WATER LICENCE INSPECTION FORM

Water Use:			Erosion / Sediment	C	4			
Recirculation (y /n)			Mitigation Measures	Α	3	Administrative		10
			Reclamation Activities			Records	Α	13
			Materials Storage	С	10	Reports	Α	14
Waste Disposal			Signage	A	6&12	Plans		
				С	9&11			
Waste Water	С	5				Notifications	С	15
Solid Waste			Monitoring			Other		
Hazardous Waste	С	8	Sample Collection / Analysis	Α	3			
*7	The number	er in the co	omments field will correspond v	with spec	ific comn	nents provided below	/.	
Samples taken by Inspe	ector:		Location(s):					
☐ Yes ⊠ No								
SECTION 1	Comme	nts (s)	Non-Compliance w	ith Act o	r Licence	(s) Acti	on Required	(s)
			t 18, 2020, I Baba Pedersen, Re					
_			Affairs Canada, the Writer of t	-		•	_	-
		61520 issu	ued for the Municipal Use of Wa	ater and '	Waste Di	sposal in the Hamlet	of Kugluktuk	in the
Kitikmeot Region of Nu

Description: View of Sewage Lagoon showing Level of Product taken 1 Day after the Decant Program was completed on 2020 October 9

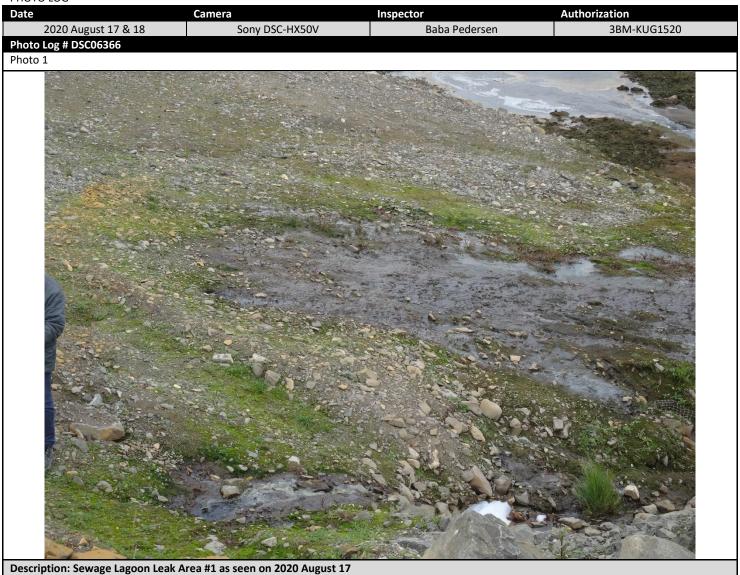
- 2. The extremely Low Level of Product within the Sewage Lagoon, with no Decant last year and this year's Decant yet to take place during the July 2 Fly-Over and the August 17 Site Visit, shows the amount of Leakage that is continually taking place. Even after the Decant Program was complete as shown in Photo 8 from October 9th, the Product Levels only went down slightly. The high amounts of ongoing, continual leakage are a major concern that requires a Permanent Solution.
